UNITED STATES PATENT AND TRADEMARK OFFICE

09/172,553

Office Action Summary

DETAILED ACTION

F I G . 4c

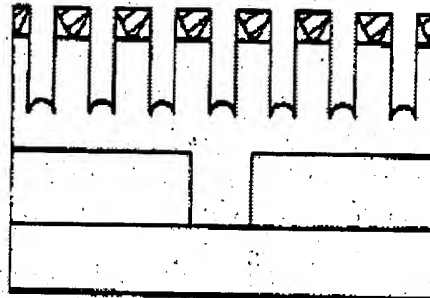
Regarding claims 31-32, 35 and 43, Jun et al. teaches an intermediate semiconductor capacitor structure (see figure 4c) comprising: a storage poly structure (13) comprising a plurality of contiguous mesas (consider the fingers or columns that include mask 15 and HSG 14 in fig 4c) with recess formed therein (consider the space between the fingers or columns in fig. 4c); a contiguous hemispherical-grain polysilicon (14) over said storage poly structure (13) (see fig. 4c) and a mask (15) over said hemispherical-grain polysilicon layer (14), said recesses (consider the space between the fingers or columns) being exposed through said contiguous hemispherical-grain polysilicon (14) and said mask (15) (see figure 4c).

With regards to the terms "contiguous mesas" or "contiguous webs", please refer to figures 4c and 6c, below. Please note that figure 4c shows shallow recesses that do not disturb the continuity of the storage poly structure 13. Thus, figure 4c shows storage poly fingers connected throughout in an unbroken sequence.

F I G . 6c

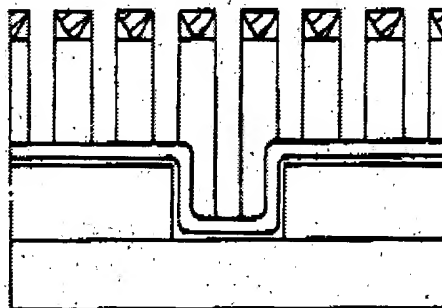
By the contrary, figure 6C shows deep recesses that disturb the continuity of the fingers. Thus, in this case figure 6c does not show contiguous fingers. Therefore, the terms "contiguous mesas" or "contiguous webs" in view of Jun et al. will be define according to figure 4c, in which shallow recesses are provided without disturbing the continuity of the storage poly.

Fig. 22

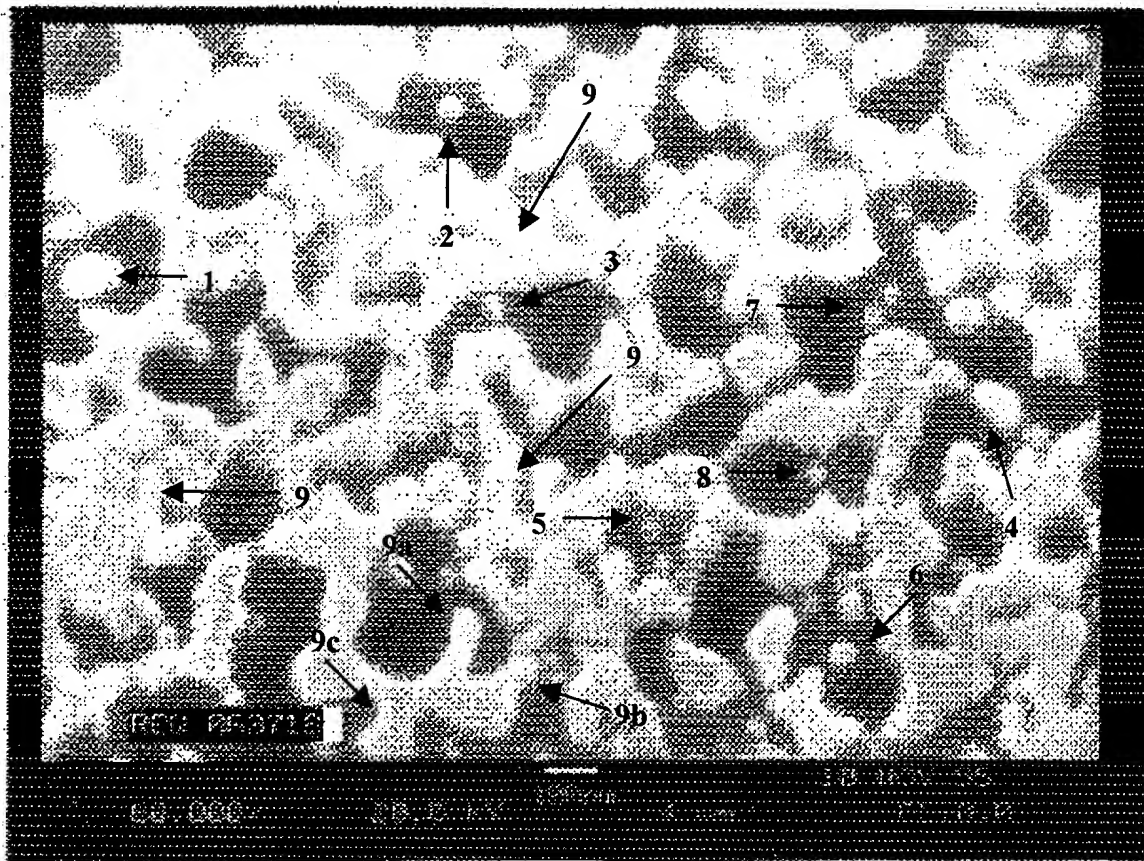
In addition, applicant also argues that Jun does not teach "a plurality of contiguous mesas" or "HSG having a web-like appearance." However, the examiner disagrees. On page 8 of Applicant's remarks, Applicant defined the terms "mesas" and "webs" as top surfaces of the storage poly. Based on such definition, Figure 22 (see below) shows, for example, top surfaces 1-9. It is noted that none of such "top surfaces" are contiguous as applicant argued. For instance, the "top surfaces" 1-8 are spaced apart from the main top surface 9.

A mesa or web defined as a mere portion or region of a top surface. For example, the mesas or webs (fingers 9a-9c in figure 22, above) are “contiguous” because they share the same top surface (9).

Fig. 9

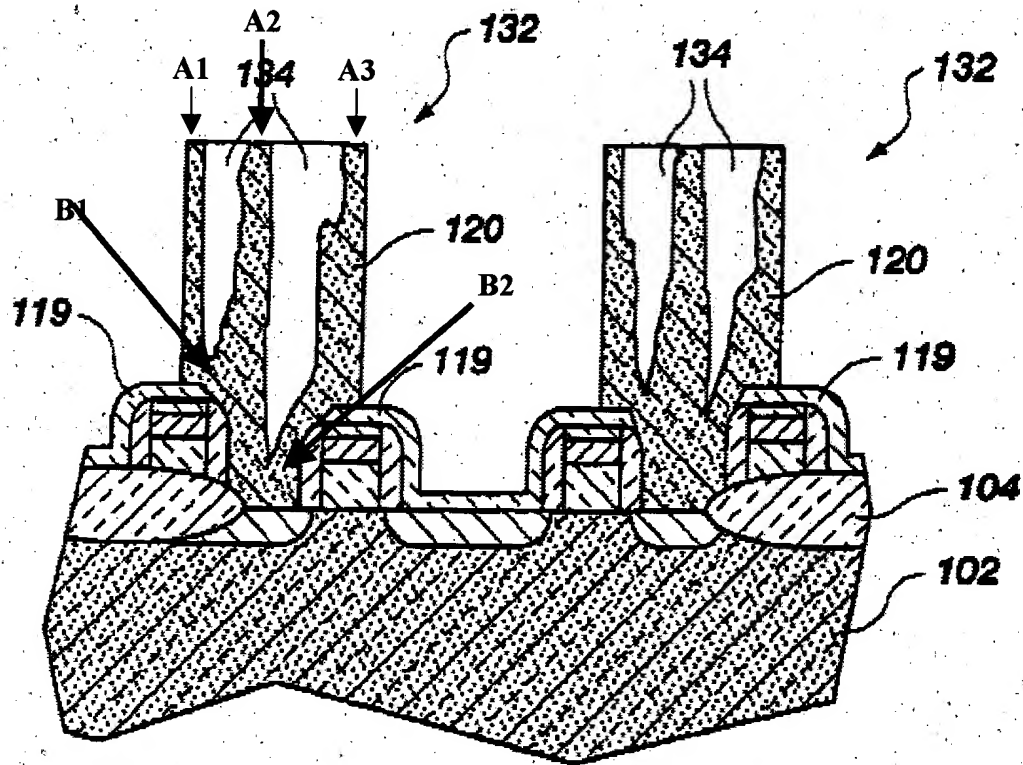
The mesas or webs are contiguous by sharing the same base. For example, top surfaces A1 and A2 share base (B1); and A2 and A3 share base (B2), which is adjacent to base (B1) (see fig 9, below).

Therefore, based on these interpretations it is believed that the reference Jun et al. anticipate the claimed invention. As such, the rejection under 35 U.S.C. 102(b) is considered to be proper.
